Subject: Description of Permissive Change

FCC ID: 2AJ3WEBEQPW92

Model Name: EBE-QPW92

PCB board of EBE-QPW92

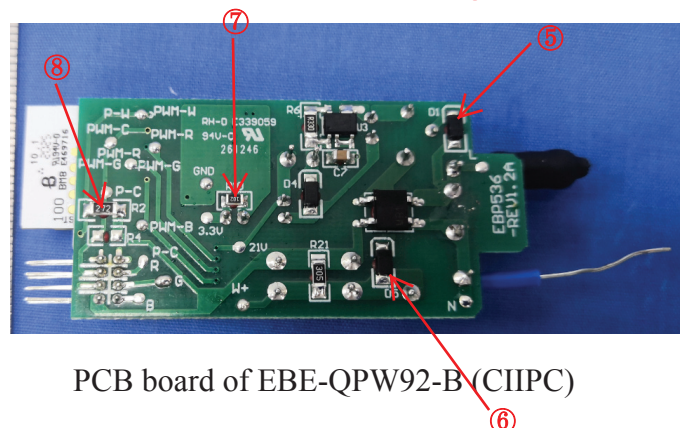
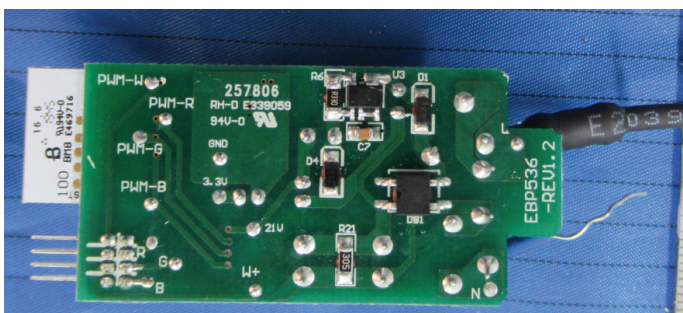
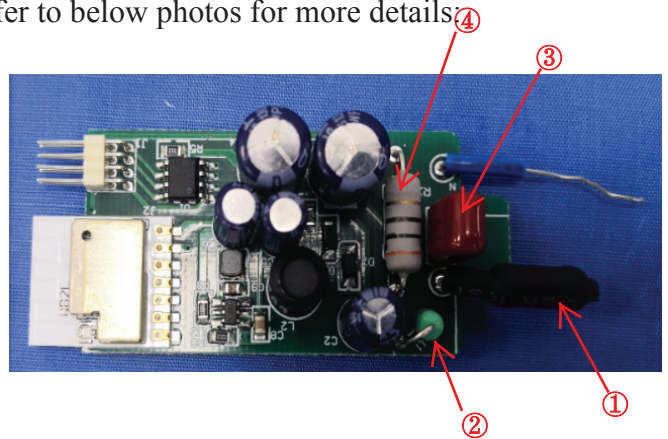
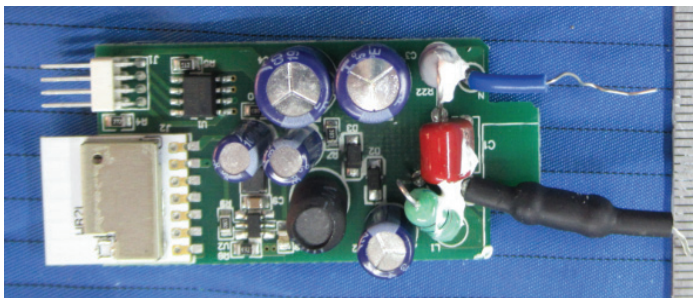
1. Add models: EBE-QPW92-B, BW904, BW914, BW924, BW944, BW210, BW010, BW310, BW410. And EBE-QPW92-B has been tested by BACL.
2. Comparing with the original tested model EBE-QPW92, the current tested model EBE-QPW92-B changed some components of PCB board. Please refer to below photos for more details:

- ①: The diameter of L wire was changed from 0.72mm to 0.55mm.
- ②: The 5*12 1mH color code inductance was changed to 4*10 2.2mH color code inductance.
- ③: 250V/220N was changed to 250V/100N
- ④: R22 safety resistance was changed from vertical type to horizontal type.
- ⑤: Changed the position of Diode D1.
- ⑥: Added the diode D5.
- ⑦、⑧: The postions of these two chip resistors are shifted from the top layer to the bottom layer.
